Re: Draft Final Remedial Action Work Plan  
LHAAP-16 Landfill  
Final Record of Decision September 2016  
Longhorn Army Ammunition Plant, Karnack, Texas

**Response to Comments on  
Draft Remedial Action Work Plan, LHAAP-16 Landfill  
Longhorn Army Ammunition Plant, Karnack Texas**

TCEQ Comments on Draft Remedial Action Work Plan, LHAAP-16

*Draft Final*  
**Remedial Action Work Plan,  
LHAAP-16 Landfill**  
Longhorn Army Ammunition Plant  
Karnack, Texas

Figure 1-3

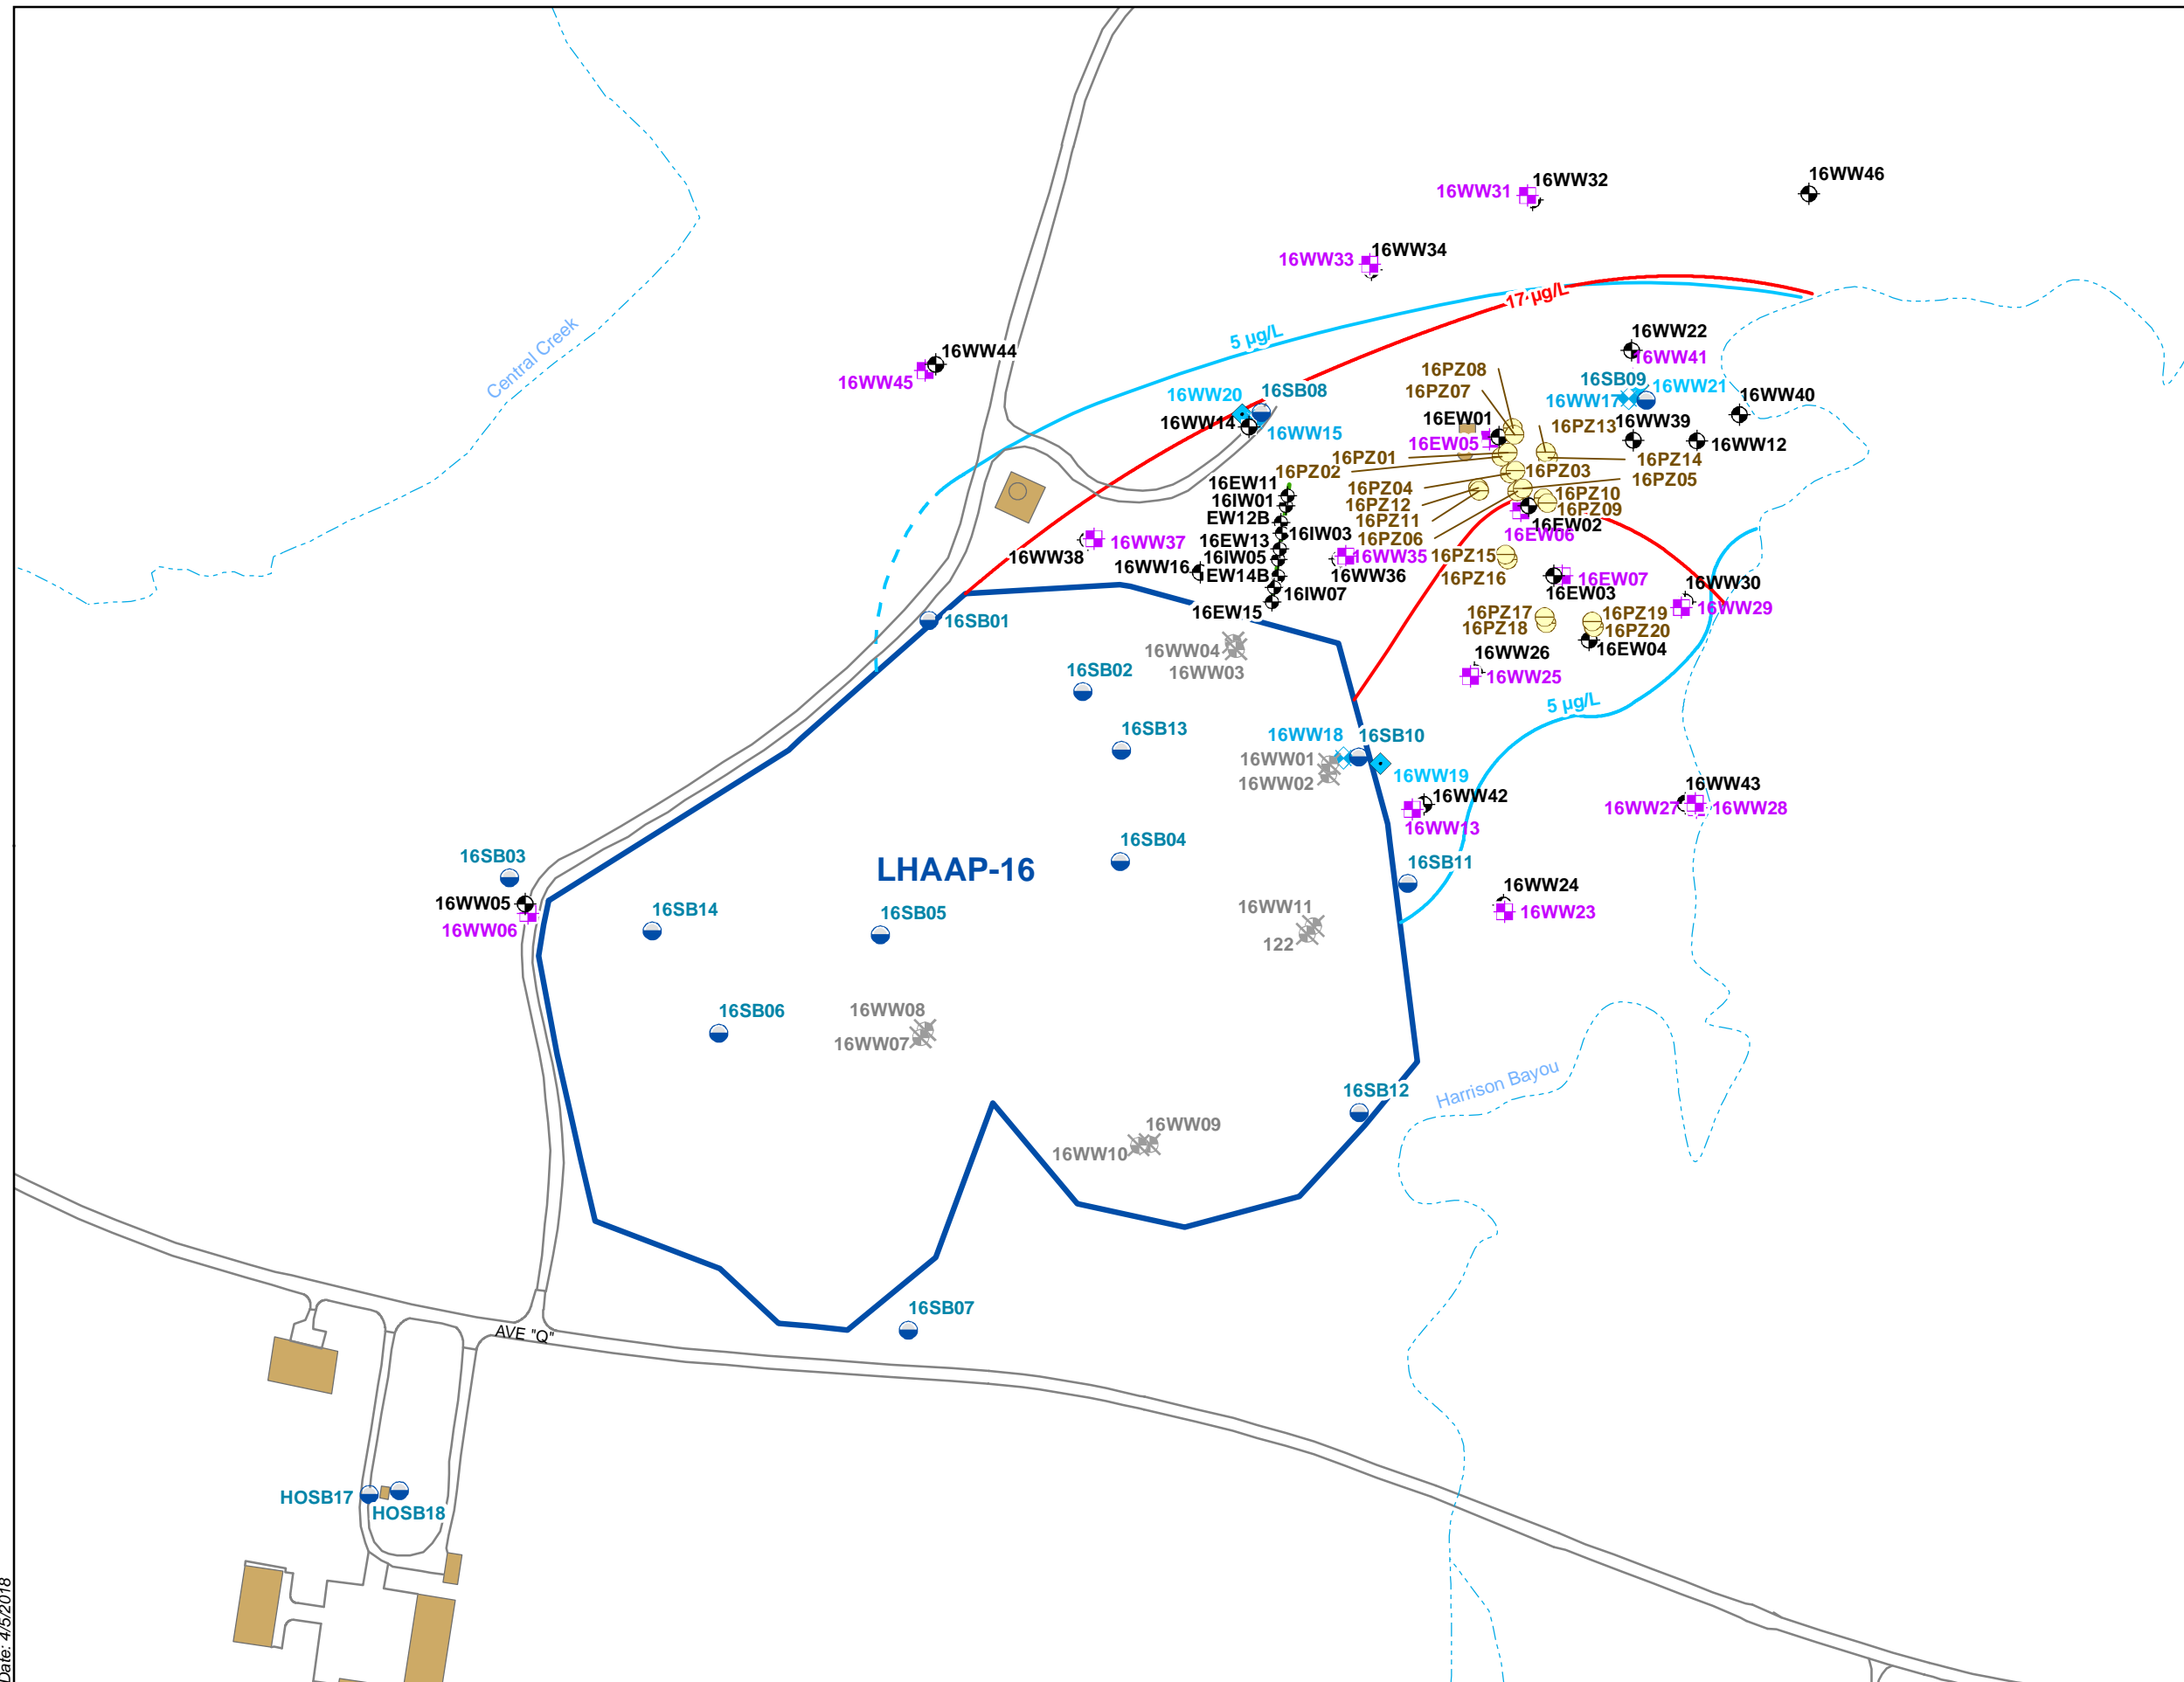
7.	Figure 1-3	In the legend there is a symbol for groundwater wells. Are these considered private home/irrigation wells? Some of these are located on Longhorn. Also, the well by the fire station is not a potable water well as the faucets in the firehouse have non-potable water signs on them.	C	Concur. The wells shown on Figure 1-3 are private wells, wells used for public supply and other wells used specifically by oil and gas companies. We received a comment from TCEQ about Figure 1-3, that the water wells shown on this figure may not be useful for remediation purpose. Figure 1-3 is being revised to remove the water wells, see the response to TCEQ's Comment 11.	A

11.	Figure 1-3	Do the private, public, and installation water wells need to be displayed on this figure? This information is helpful at remedial investigation and remedy selection phases, but not really needed for the remedial action.	C	Figure 1-3 will be revised to remove the water wells shown on the figure.

Figure 1-4  
 LHAAP-16 Site Plan  
 LHAAP-16 RAWP  
 LONGHORN ARMY AMMUNITION PLANT  
 KARNACK, TEXAS

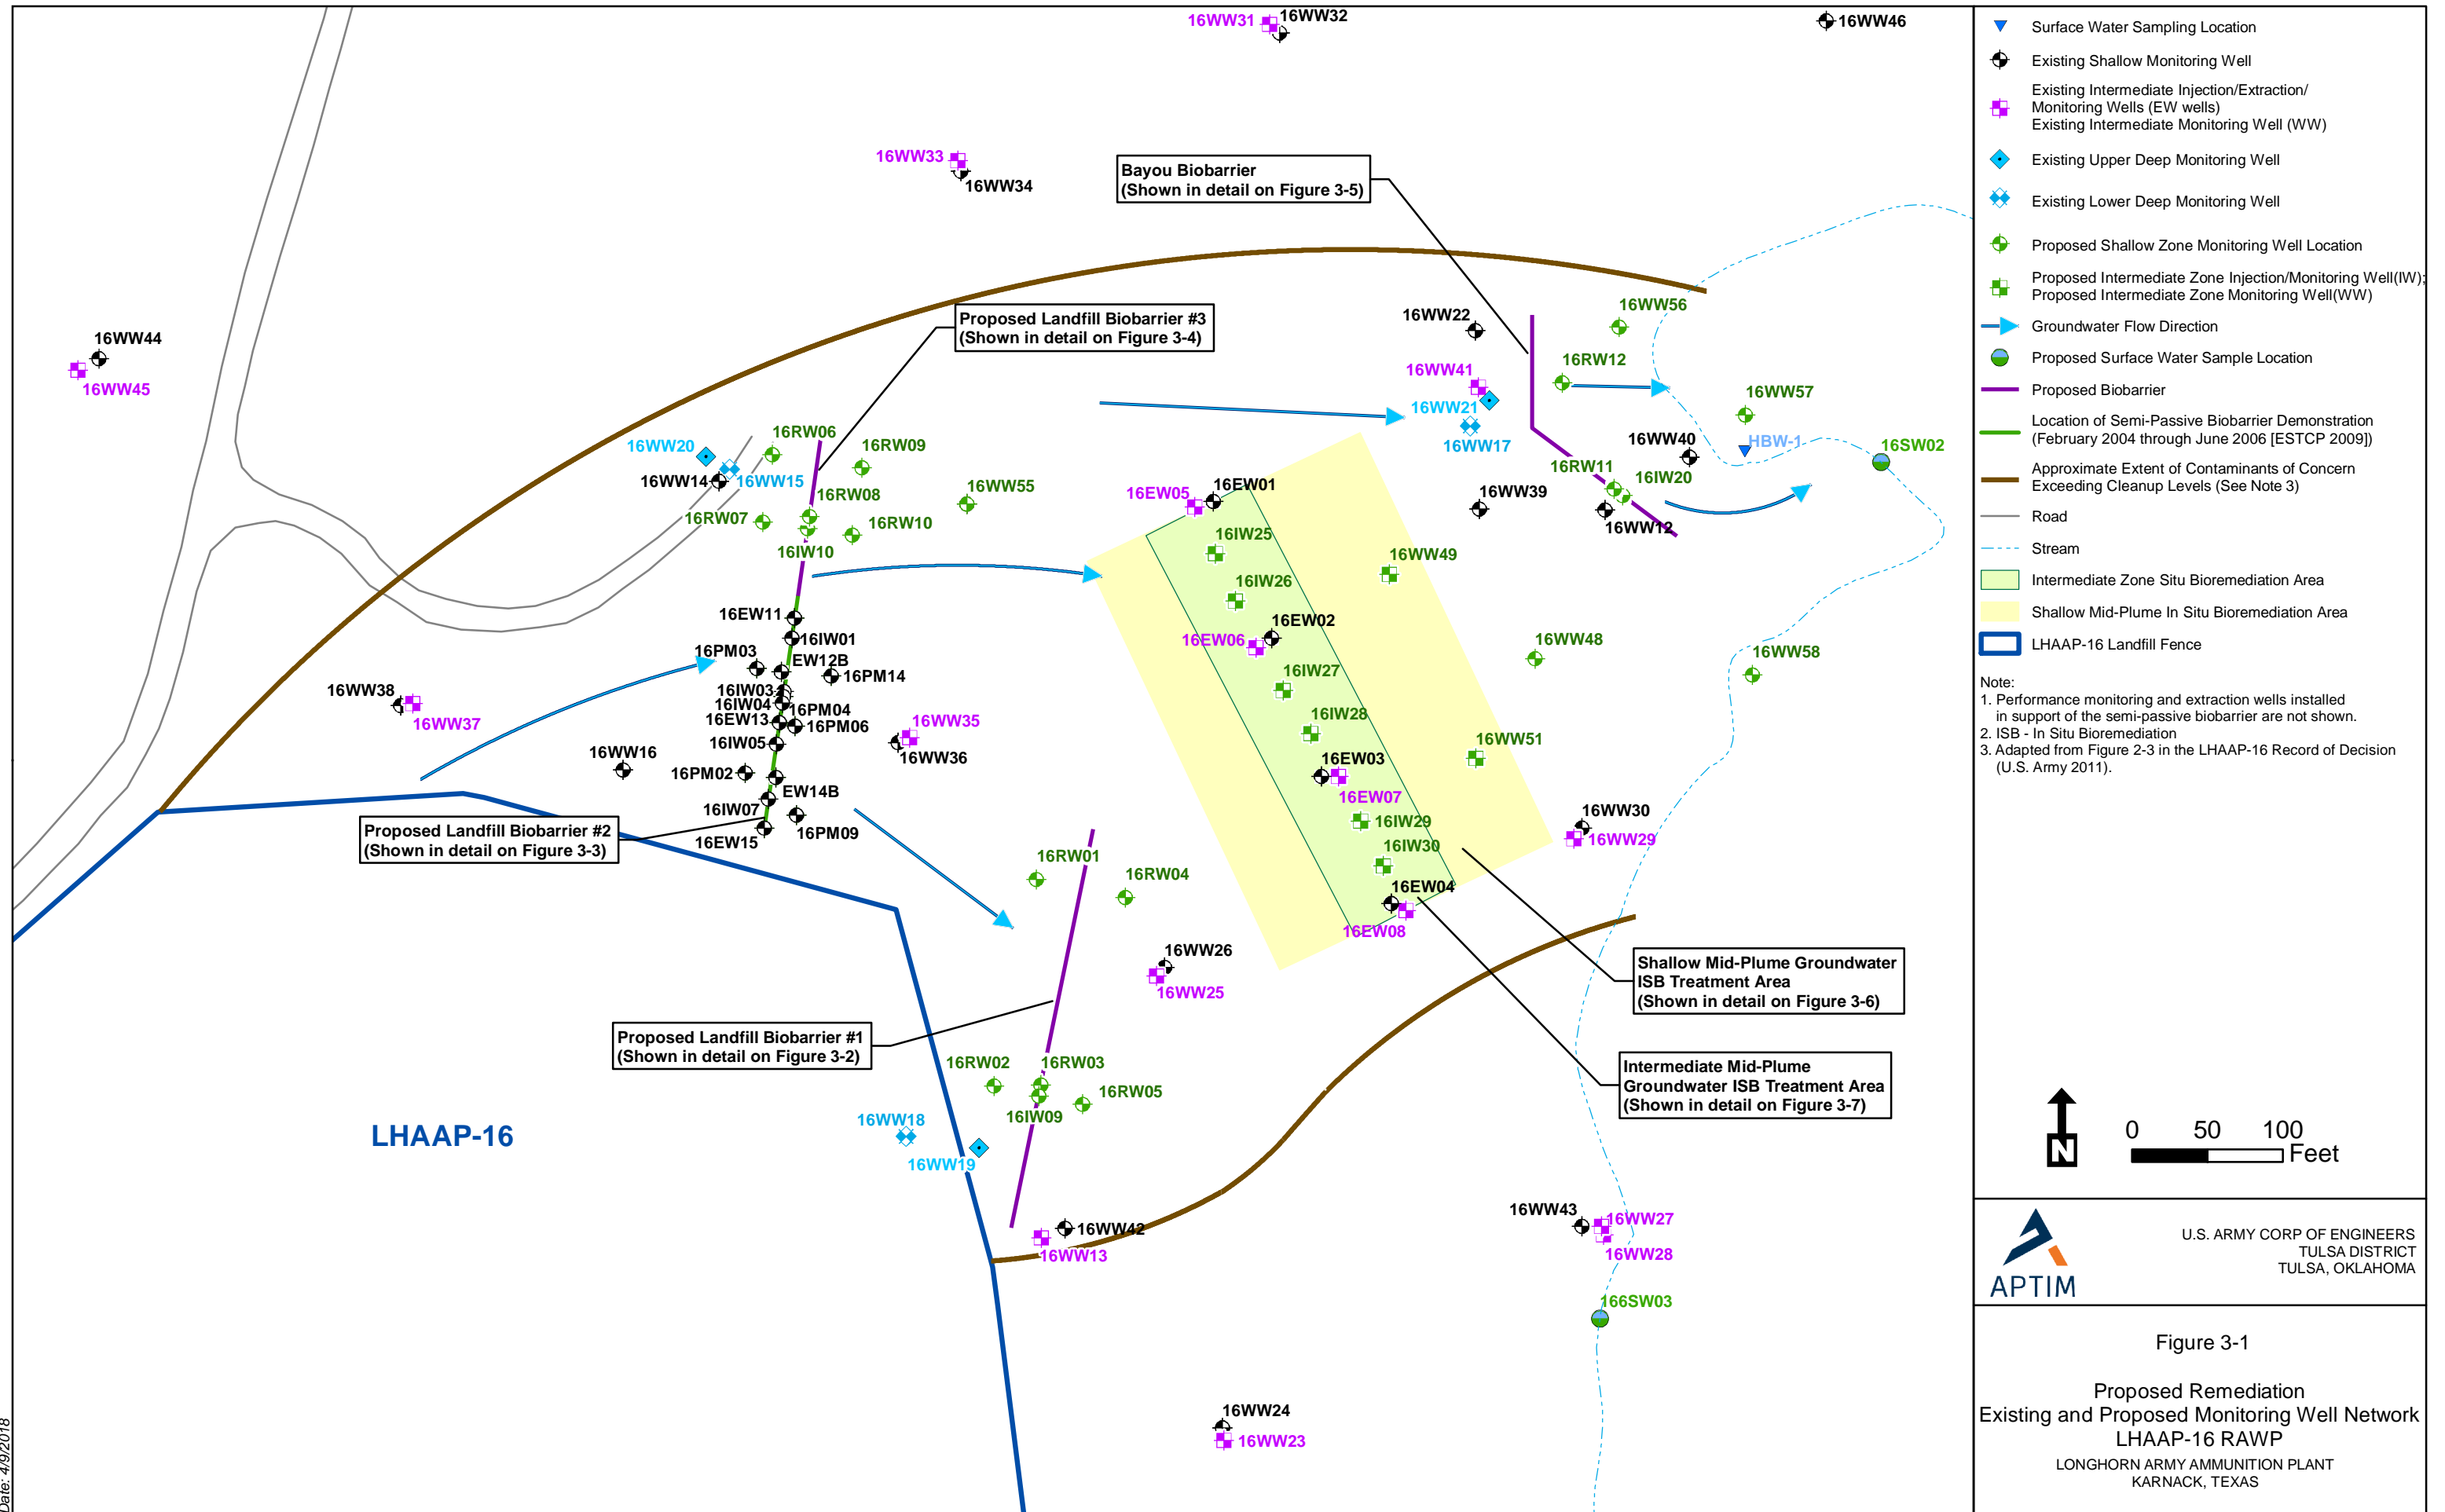
12.	Figure 1-4	Western corner of landfill, wells 16WW05 and 06 are mislabeled. Wells 16WW44 and 45 should be added to this figure (and other relevant figures)	C	Figure 1-4 will be revised to show and label wells correctly.

Figure 3-1  
Proposed Remediation  
Existing and Proposed Monitoring Well Network  
LHAAP-16 RAWP  
LONGHORN ARMY AMMUNITION PLANT  
KARNACK, TEXAS

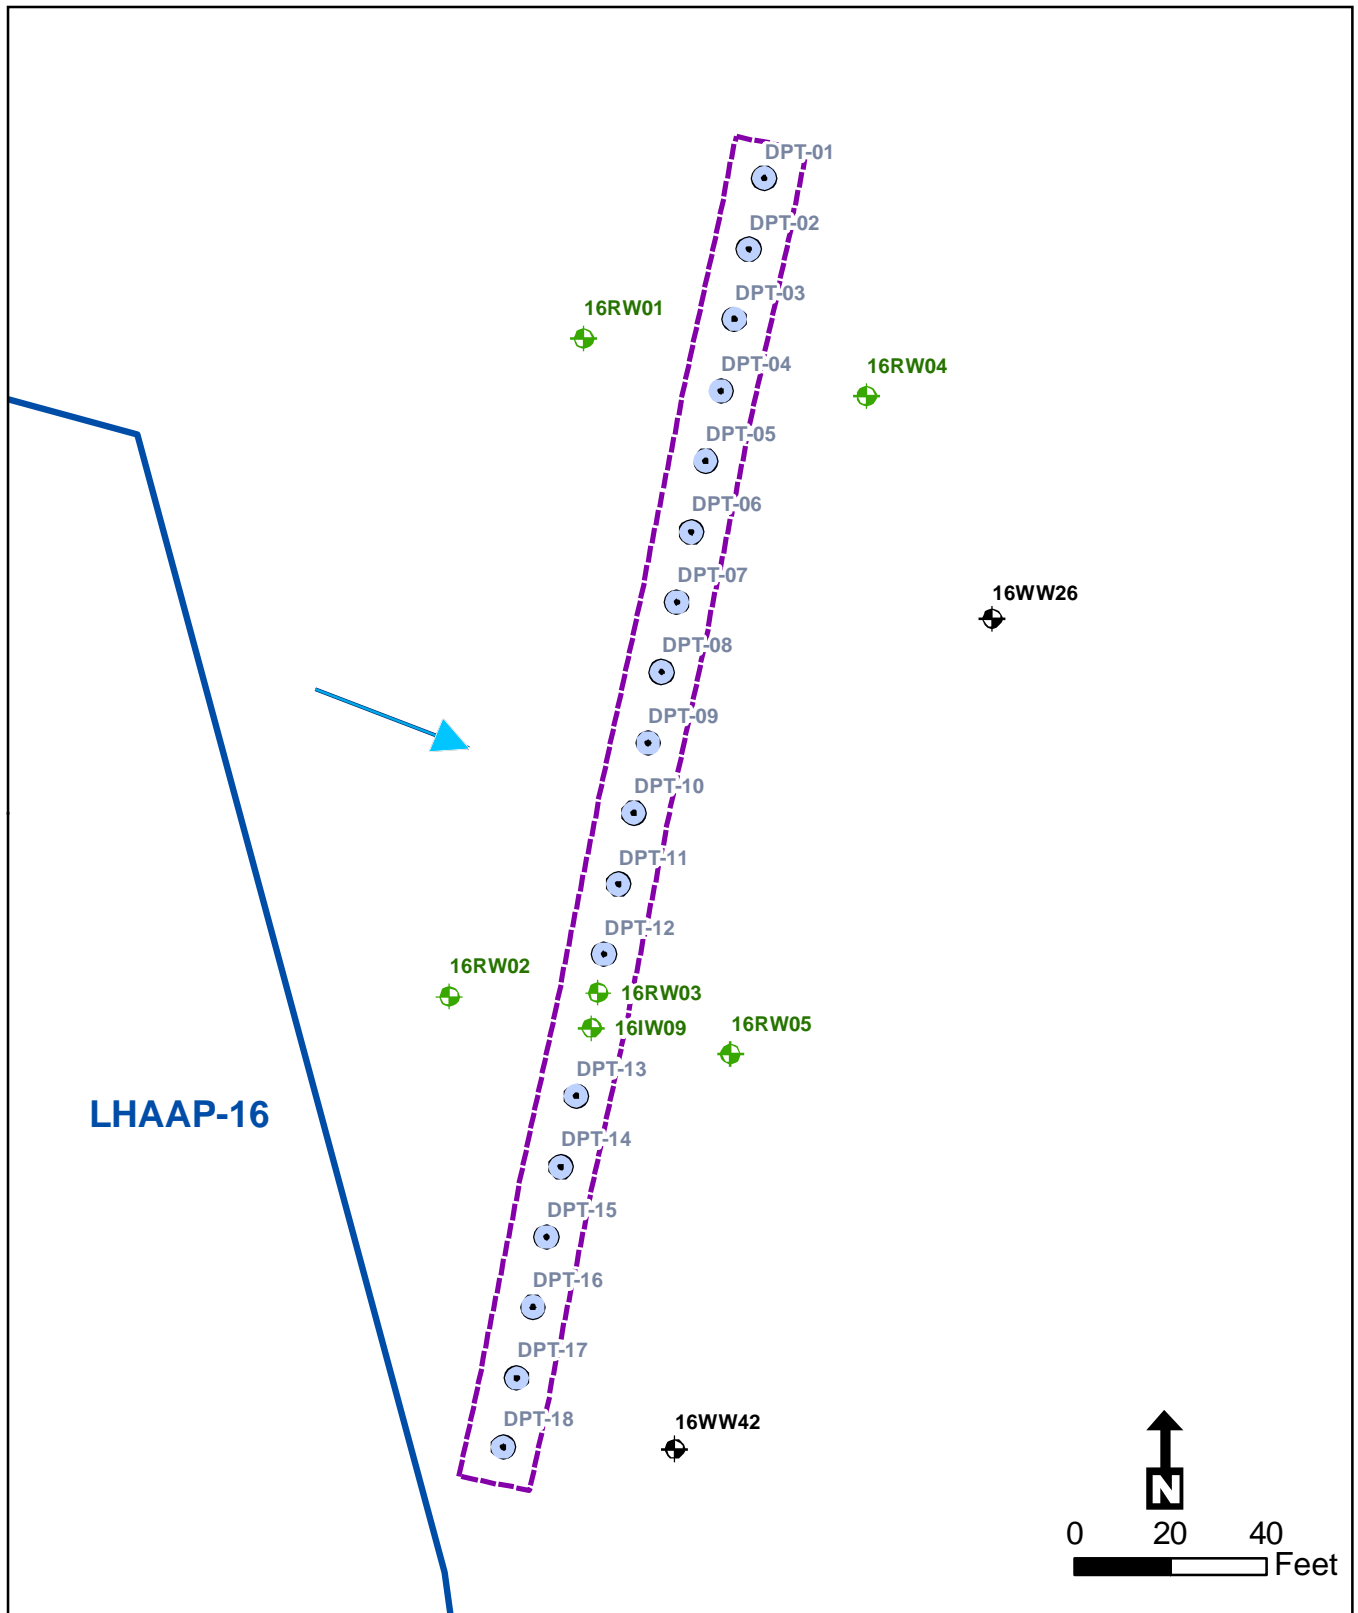
Comment Ref. #	Section, Page Ref.	TCEQ Comment	C, D, E, or X <sup>1</sup>	Response	A or D <sup>2</sup>	Army Comment
13.	Figure 3-1	Wells 16WW44 and 45 should be added to this figure (and other relevant figures)  These data points are also missing from figure:  16RW07, 16IW04, 16IW09, and 16EW08	C	Figure 3-1 will be revised to show the missing wells.		
14.	Figure 3-3	16IW04 is mislabeled (16IW-4)	C	Figure 3-3 will be revised to correct the mislabeling.		
15.	Figure 4-2	It would be better to have all permanent wells on this figure. Would it be possible to turn on the other wells? The MNA and LTM wells could be shaded/highlighted OR the wells not being used could be faded out. It would also be helpful to have the biobarrier lines drawn for reference (without details)	C	Figure 4-2 has been revised accordingly and is attached to the RTCs.
